1. MECHANICAL ADDENDUM NO. 1

2.1 Drawing No. M701 – Hot Tub Demolition Schematic:

2.2 Drawing No. M702 – Hot Tub Renovation Schematic

PROJECT TITLE:
TOWN OF PEACE RIVER - HOT TUB REPLACEMENT

HOT TUB RENOVATION SCHEMATIC
 M702 SCALE: NTS

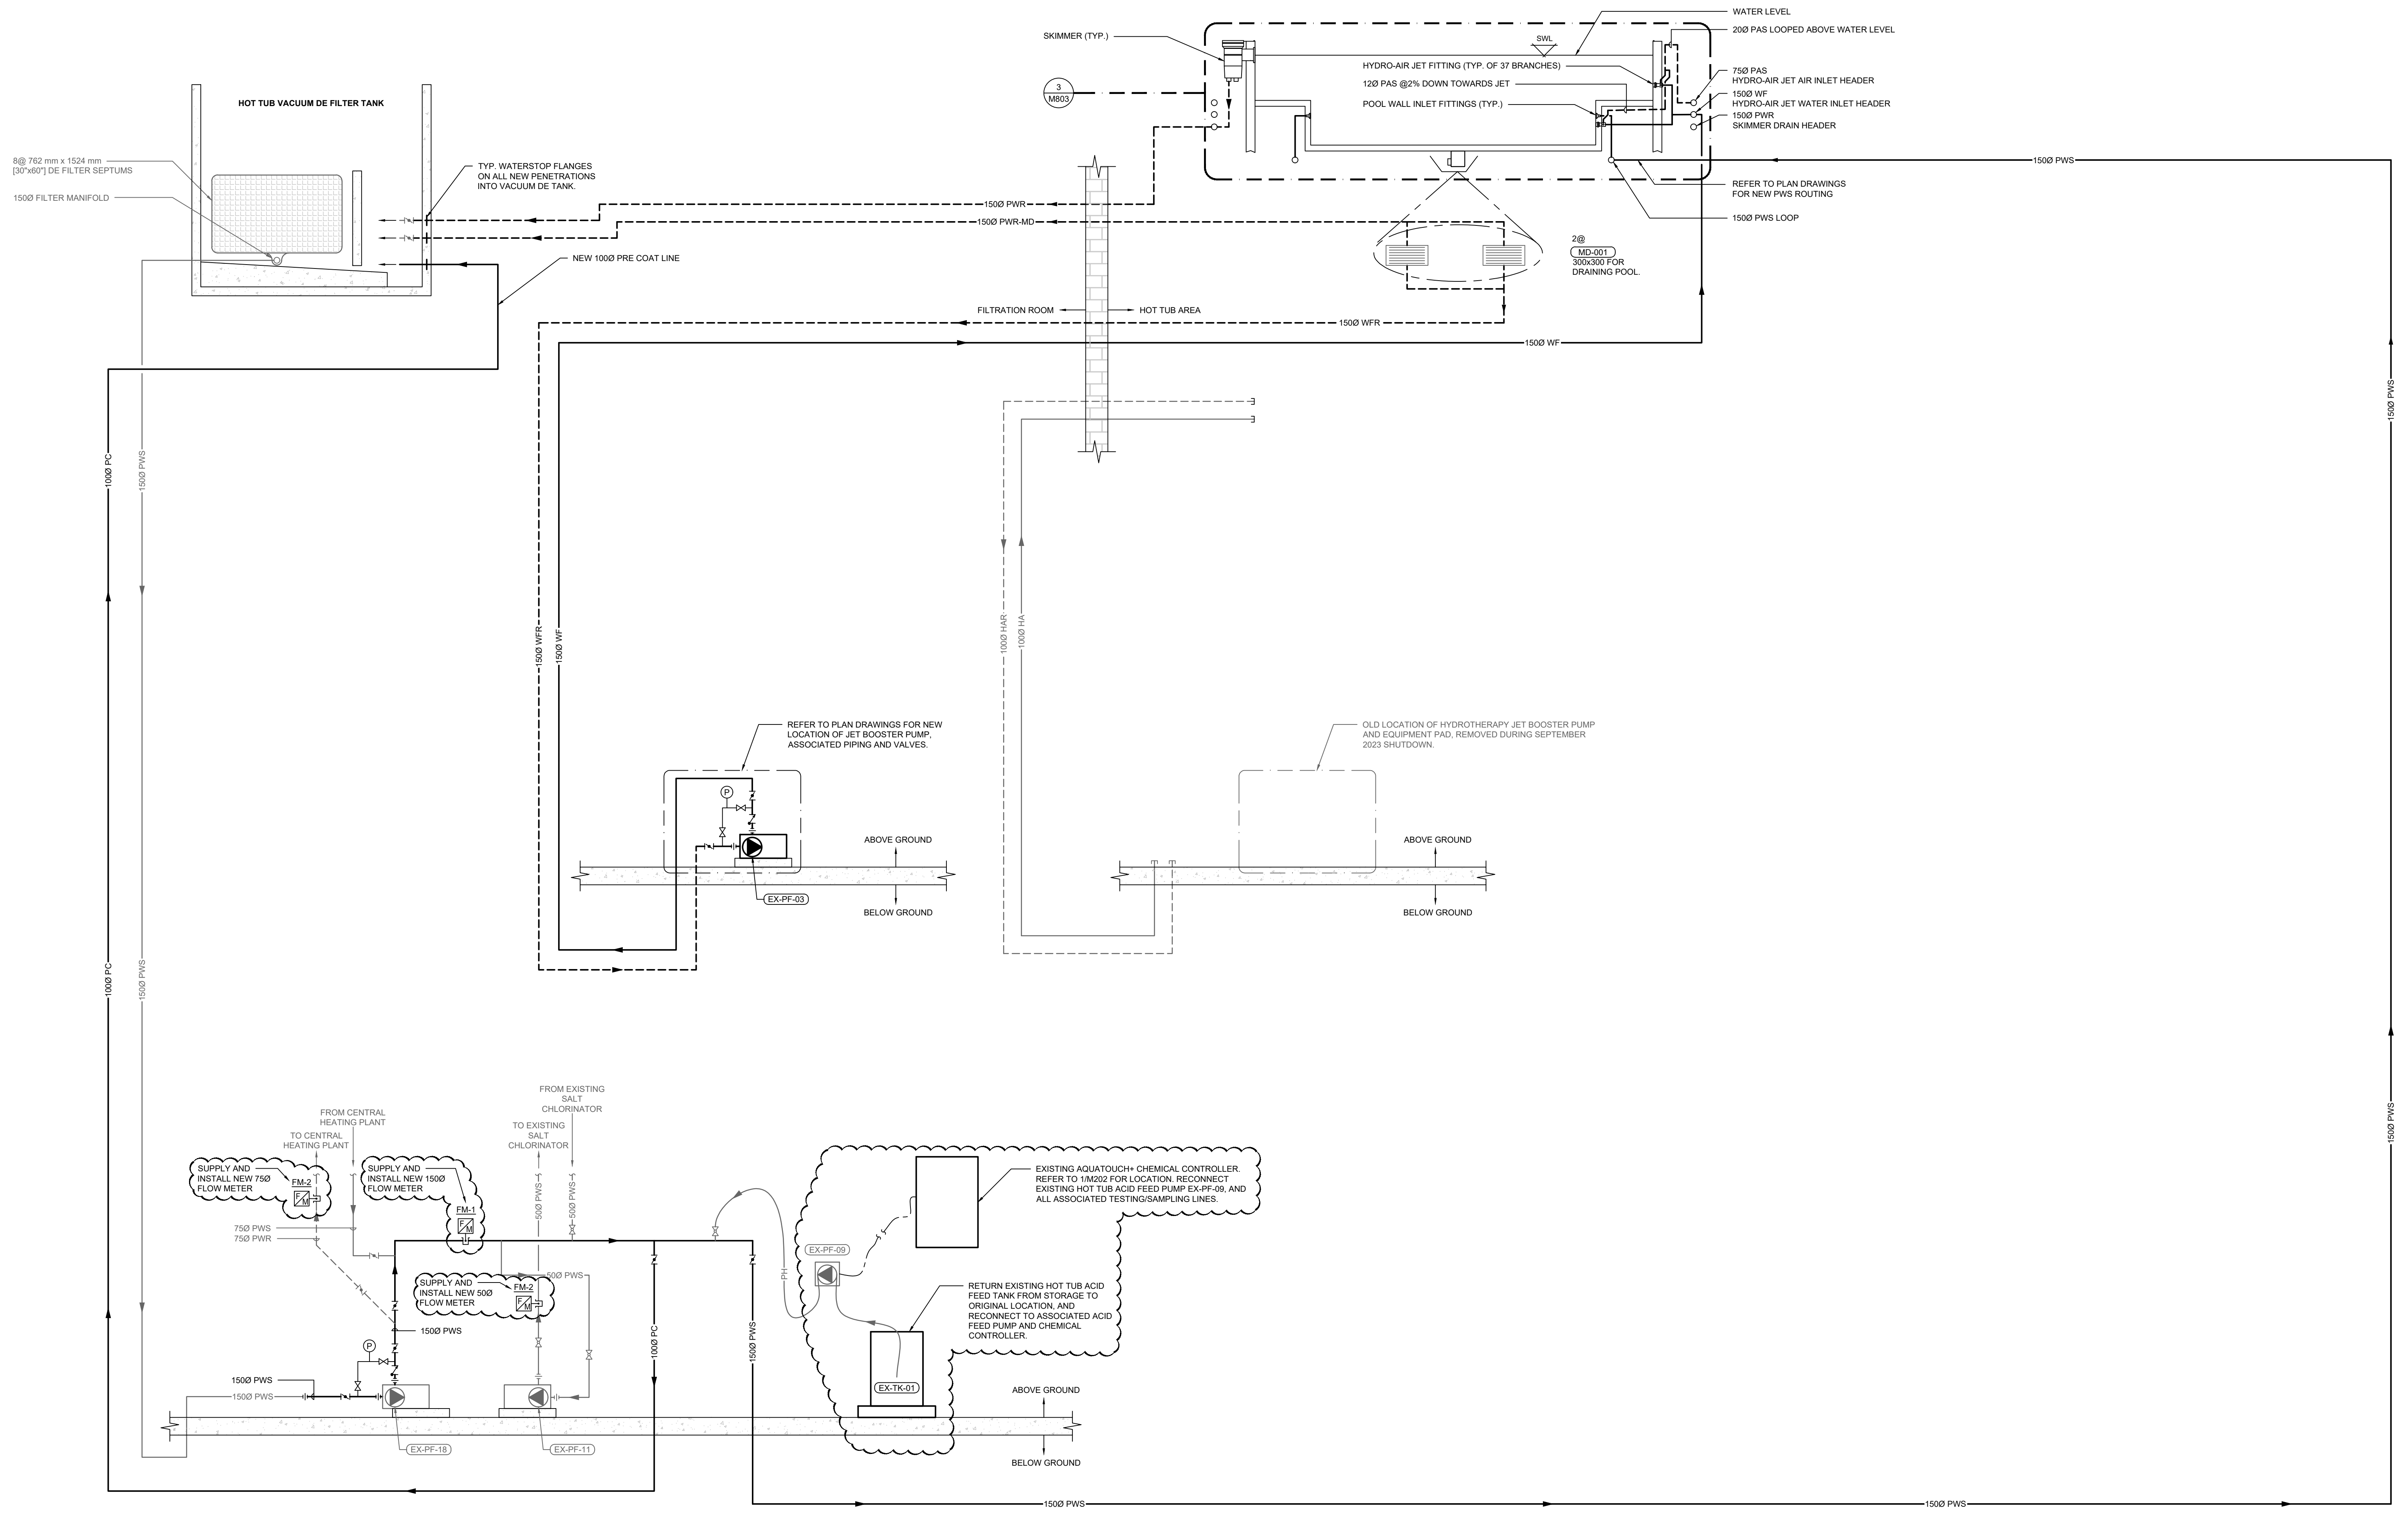
- .1 Add:
 - .1 Location of new 150Ø main circulation flow meter.
 - .2 Location of new 75Ø heating loop bypass flow meter.
 - .3 Location of new 50Ø chemical loop bypass flow meter.
 - .4 Show connection between existing hot tub acid feed pump EX-PF-09 and existing, relocated Aquatouch+ chemical controller.
- .2 Revise:
 - .1 Note about existing hot tub acid feed tank EX-TK-01 to clarify that it is currently in storage and is to be reused in new construction.
